# PRELIMINARY OVERALL AREA DEVELOPMENT PLAN 432.8 Acres

# PRELIMINARY OVERALL AREA DEVELOPMENT PLAN APPLICATION (POADP)

Re: Legacy Trails

POADP # 110 - B

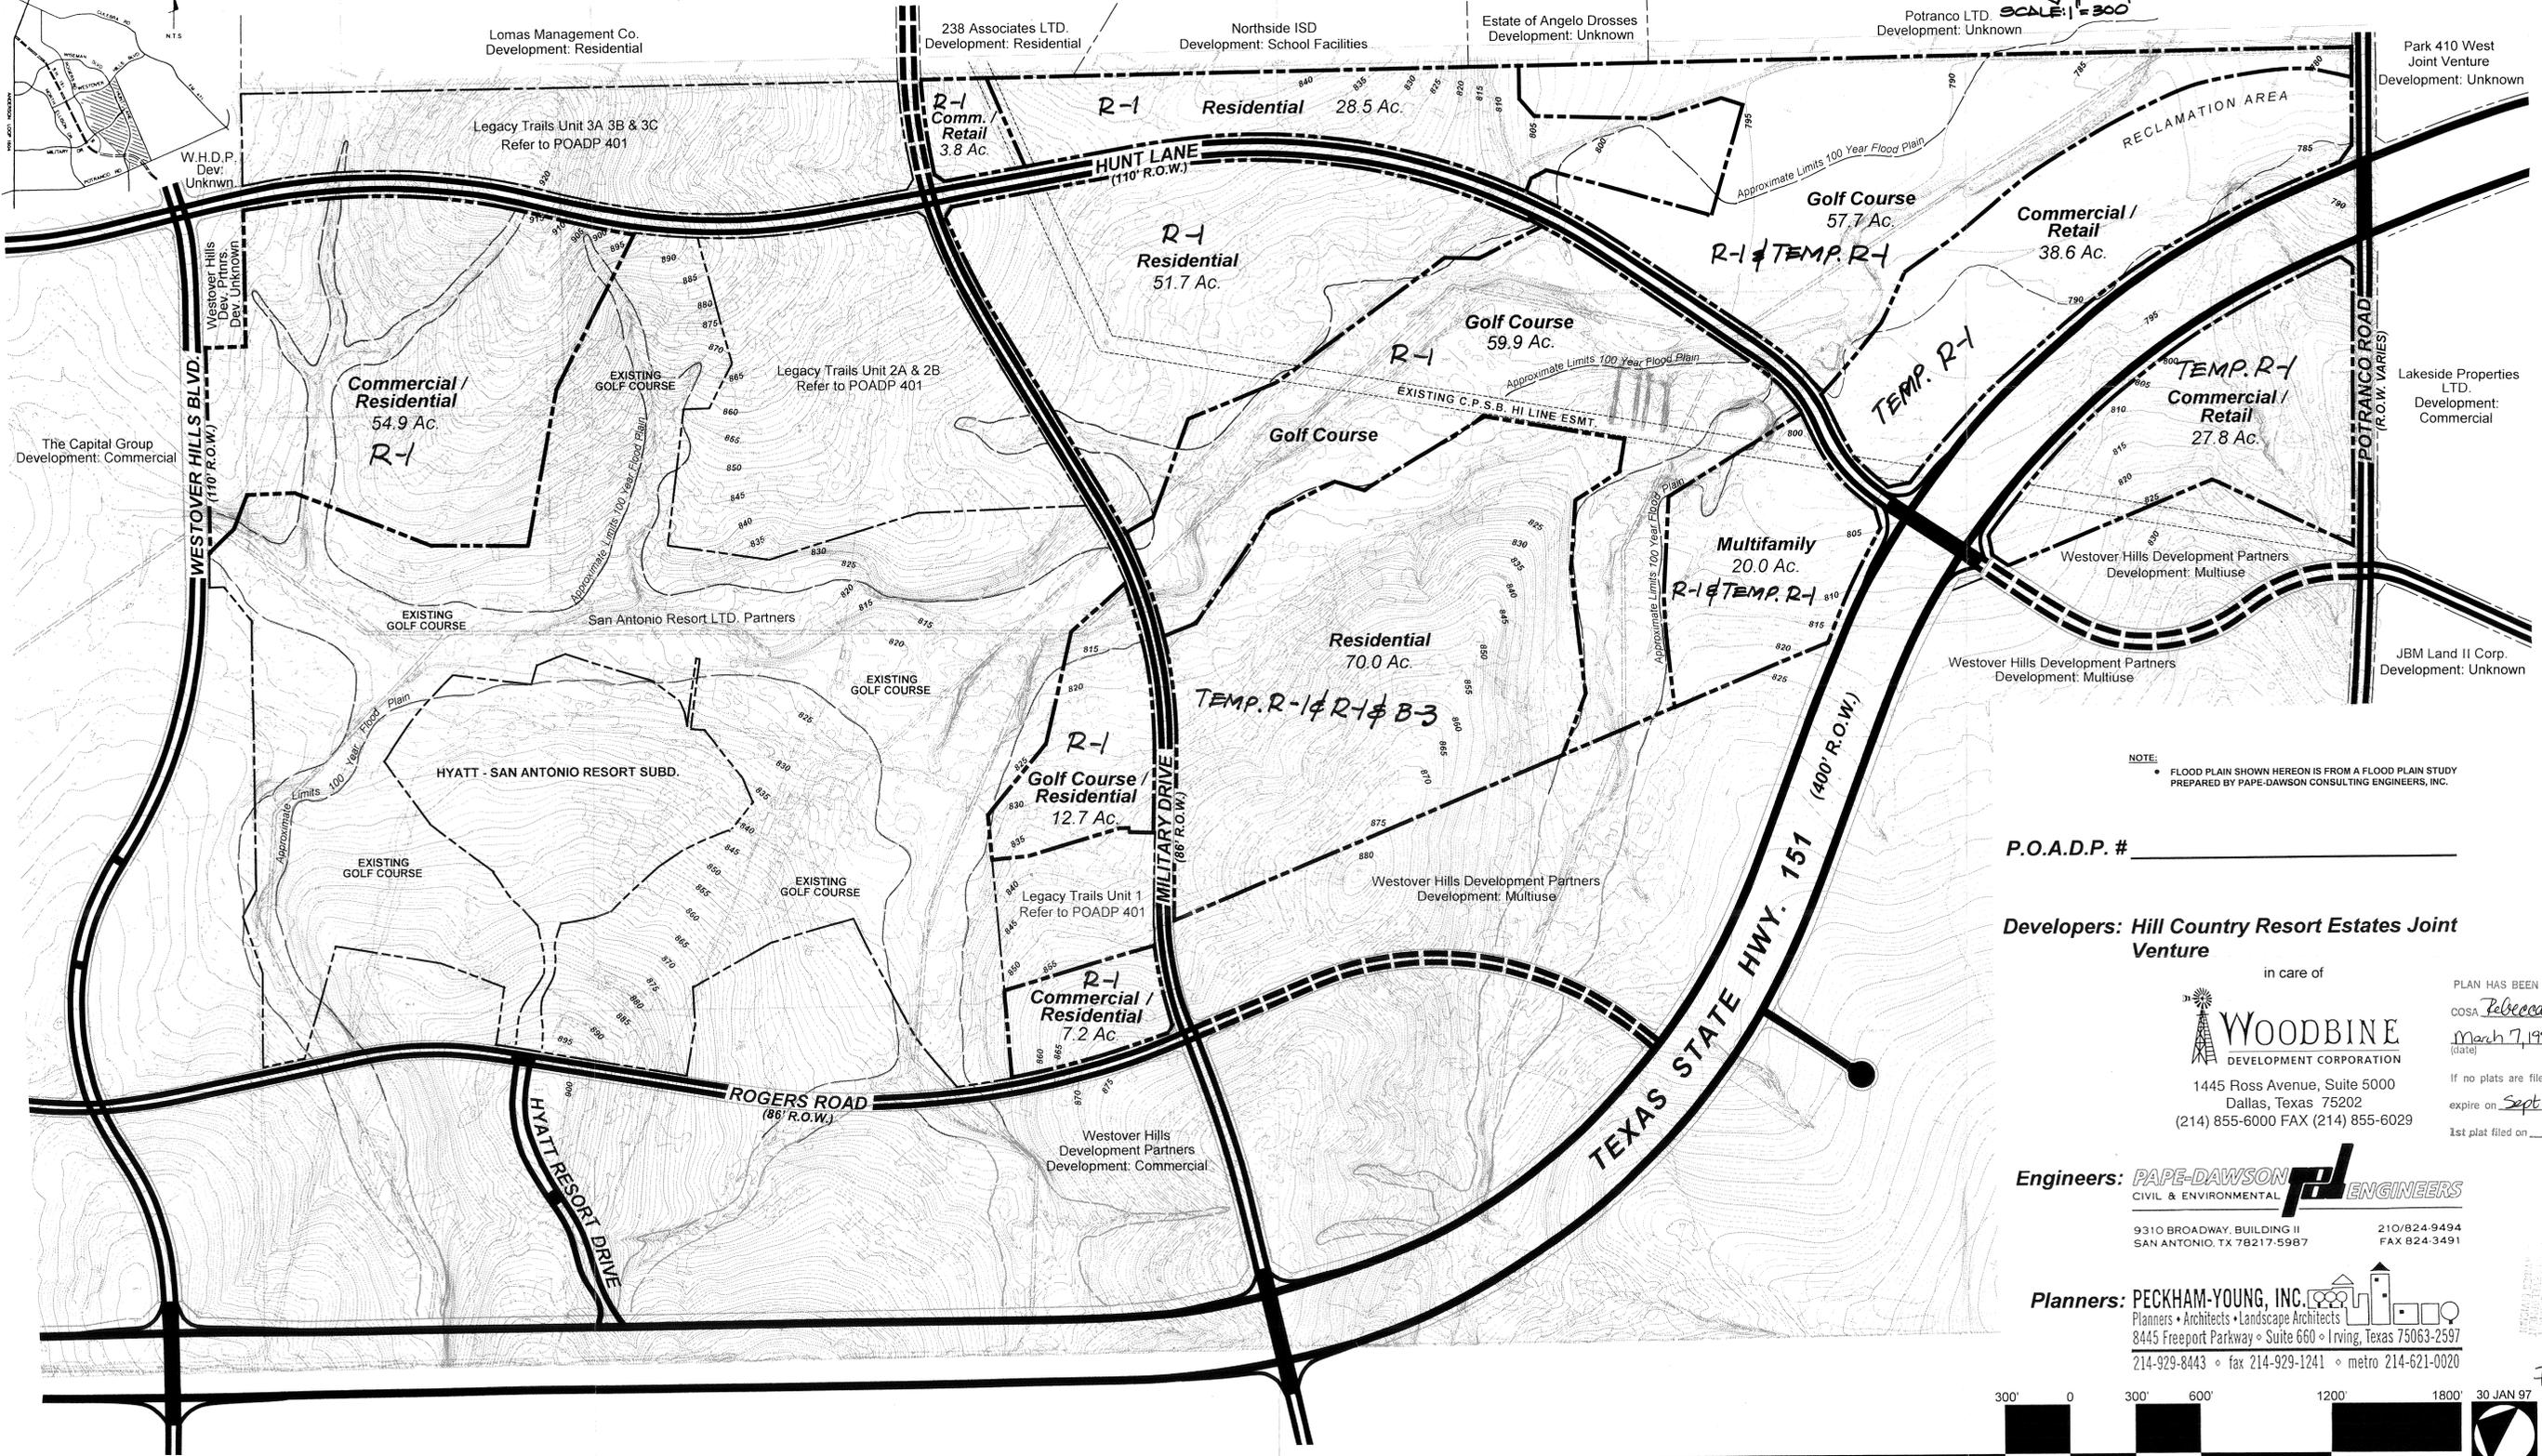
- Based on the topography, a Flood Plain Study and drainage review will probably be required during the platting process.
- Access issues along State facilities will need to be resolved with the Texas Department of Transportation (TXDOT). For additional information about these requirements you can contact TXDOT at 615-5814.

For residential development directly adjacent to State ROW, the developer shall be responsible for adequate set-back and/or sound abatement.

20.0 acre Multifamily site is eligible for a maximum of 3 access points on SH 151, 38.6 acre Commercial Retail site is eligible for a maximum of 12 access points on SH 151 & 2 access points on FM 1957, 57.7 acre Golf Course is eligible for 1 access point on FM 1957, 27.8 acre Commercial Retail is eligible for a maximum of 10 access points on SH 151 & 6 access points on FM 1957. Locations and permitting will be as directed by "Regulations For Access Driveways to State Highways".

Permit applications along with plans for street, driveway, utility, sidewalk and drainage construction must be submitted to the Texas Department of Transportation for review and approval before working on highway ROW. TxDOT requires that a recorded plat accompany all driveway permit applications. The Owner/Developer is responsible for preventing any adverse impact to the existing drainage system within highway ROW.

Comments: Show collector steel  
network system
